CALIFORNIA COASTAL COMMISSION

STAFF REPORT: REGULAR CALENDAR

APPLICATION NUMBER: 5-08-204

PROJECT LOCATION: 214 Avenida Montalvo, San Clemente, Orange County

SITE / BUILDING SECTION 'A'

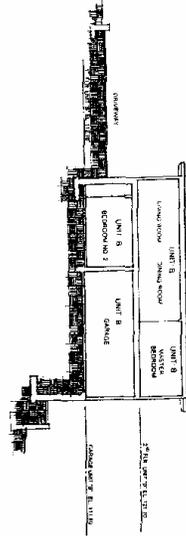
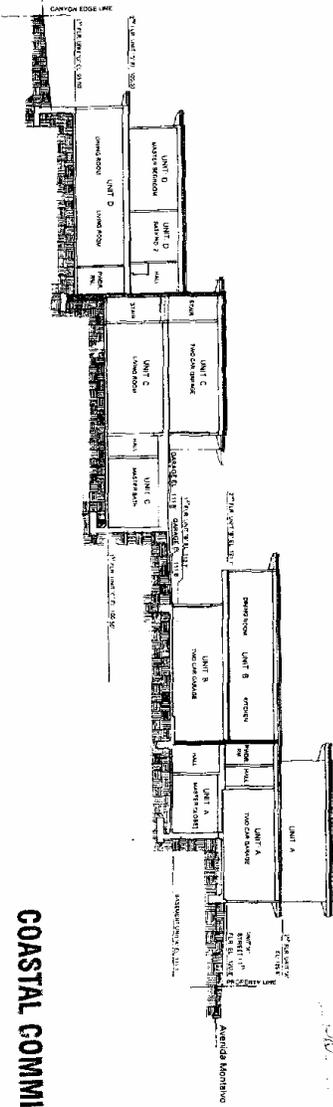
The subject site and views of Montalvo Canyon are visible from across the canyon at the Calle Majorca cul-de-sac. The canyon bottom stream is not visible as it is shaded by riparian vegetation. As proposed the two, two-story, two-unit/two car garage buildings would step down the gently sloping lot into the canyon to the 94' to 95' contour line. A topographic map is included as Exhibit 9. Additionally, 1,350 cubic yards of fill up to approximately the 94' contour line for site preparation is proposed. The fill for the building closest to the street (Unit A and Unit B) would bring

the finished floor for the ground floor Unit B from approximately the 105' contour to the 112' contour (7 foot difference) and for the building closest to the canyon/wetland (Unit C and Unit D) would bring the finished floor from the 96' contour to approximately the 100' contour (5 foot difference) as depicted on elevation building sections on pages 4 and 5 of Exhibit 5.
